Point Beach Nuclear Plant Units 1 and 2
Dockets 50-266 and 50-301
License Nos. DPR-24 and DPR-27

Response to Request for Additional Information:
Request For Exemption to 10 CFR 50, Appendix R (TAC Nos. MC2267 and MC2268)

RESPONSE TO REQUEST FOR ADDITIONAL INFORMATION REGARDING REQUEST FOR EXEMPTION TO 10 CFR 50, APPENDIX R POINT BEACH NUCLEAR PLANT UNITS 1 AND 2

ATTACHMENT 1
FIGURE 1
8' ELEVATION

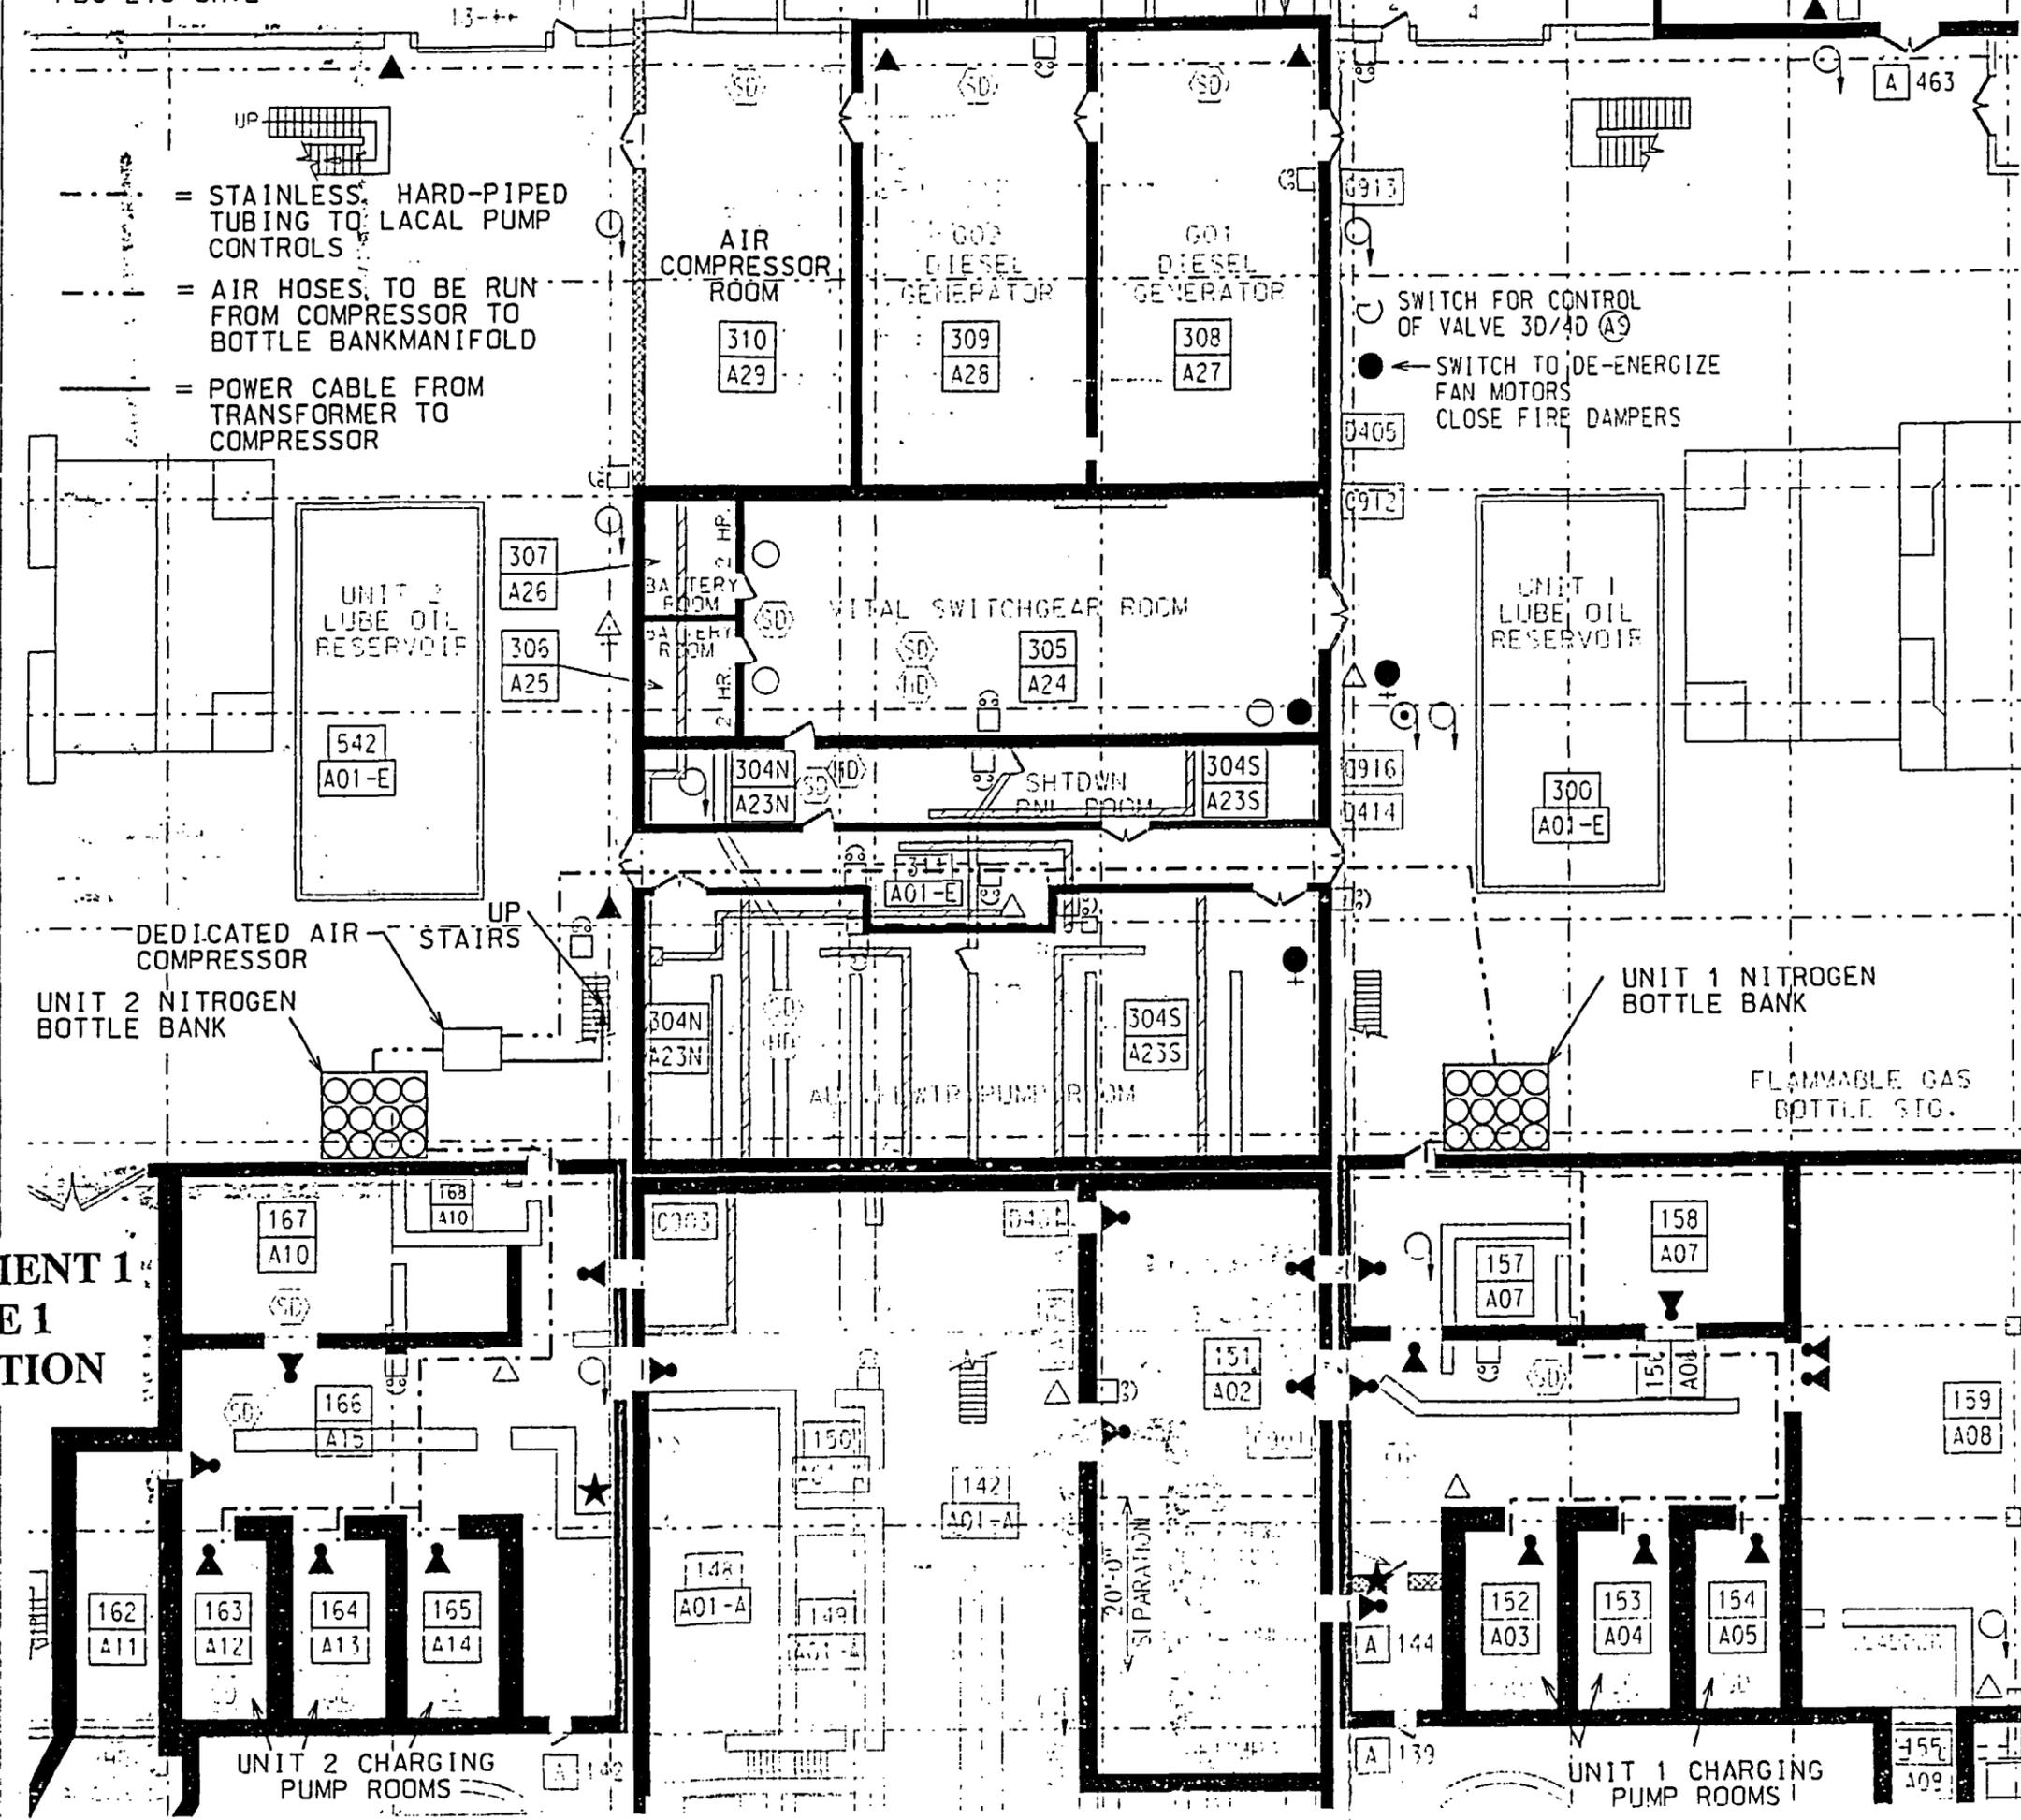
Please provide a graphical layout of the plant locations in question, including the charging pump room(s), the primary air compressor location(s), the backup N2 bottle manifolds, the dedicated air compressor, and the routes over which the electrical lines and pneumatic hoses would be laid out.

Where are the fire locations that would create the loss of primary air supply? How are they separated from the N2 bottled gas? How are they separated from the dedicated air compressor, electrical line, and hose storage locations?

Figure 1 depicts the 8' (above lake level) elevation of the plant. Most of the equipment of concern is located on this figure. Near the upper left corner is the air compressor room containing all of the normal instrument and service air compressors. To the lower right and lower left are the six charging pump cubicles (three per unit) for Units 1 and 2, respectively. At left center are both the dedicated air compressor and the nitrogen bottle bank for Unit 2. The hoses for the compressor are stored in a metal storage box adjacent to the air compressor in the same fire zone. The power cords for the compressor are stored in a metal storage box on the 26' elevation of the Turbine Hall near the portable A-frame transformer (X-71). The nitrogen bottle bank for Unit 1 is shown at center right. The various hose and power cable routings are also depicted, as are the hard-piped tubing runs between the nitrogen bottle banks and the charging pump cubicles.

- 8' level of the central Auxiliary Building (Area A01A shown in Figure 1 of Attachment 1),
- Pipeway #1 (Area A08 shown in Figure 1 of Attachment 1),
- Pipeway #4 (Area A11 shown in Figure 1 of Attachment 1),
- 2P2A Charging Pump Room (Area A14 shown in Figure 1 of Attachment 1),
- North Auxiliary Feed Water pump room (Area A23N shown in Figure 1 of Attachment 1),
- South Auxiliary Feed Water pump room (Area A23S shown in Figure 1 of Attachment 1),
- 4KV Vital Switchgear Room (Area A24 shown in Figure 1 of Attachment 1),

ATTACHMENT 2
FIGURE 1

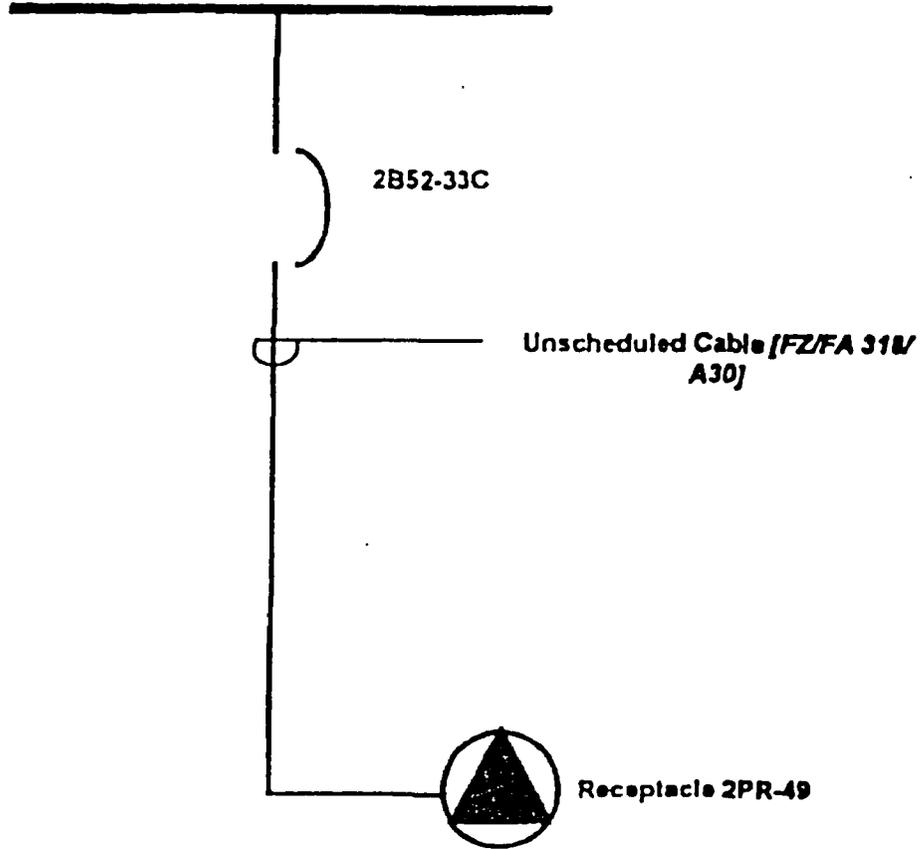
Discuss the proposed 480V electrical power supplies and the analysis that shows they are not subject to common mode power supply/enclosure failures with the primary air supply. Is there a fire that can cause the loss of primary air and the loss of the electrical supply to the dedicated air supply?

Attachment 2, Figures 1 and 2, show graphically the power scheme development for the two different power supplies, 2B-03 and B-08 (each a 480 VAC 3-phase welding receptacle) and illustrates that the power for these supplies derive from diverse sources.

Load centers 2B-03 and B-08 are safe shutdown power supplies that have been evaluated for their post fire availability for each fire area. Load center 2B-03 is either

unaffected by fire or can be restored by operator action for all fire areas except in the Control Room (Area A31; Figure 3 of Attachment 1), Cable Spreading Room (Area A30; Figure 2 of Attachment 1), 4160V Vital Switchgear Room (Area A24; Figure 1 of Attachment 1), and the Auxiliary Feedwater Pump Room (Area A23; Figure 1 of Attachment 1). For any of those cases, power to the alternate receptacle (PR-93, powered from PP-70 and B-08) remains available. The two receptacles are physically located in different fire areas and there are no power supplies or enclosures associated with the two circuits that are located in a common fire area.
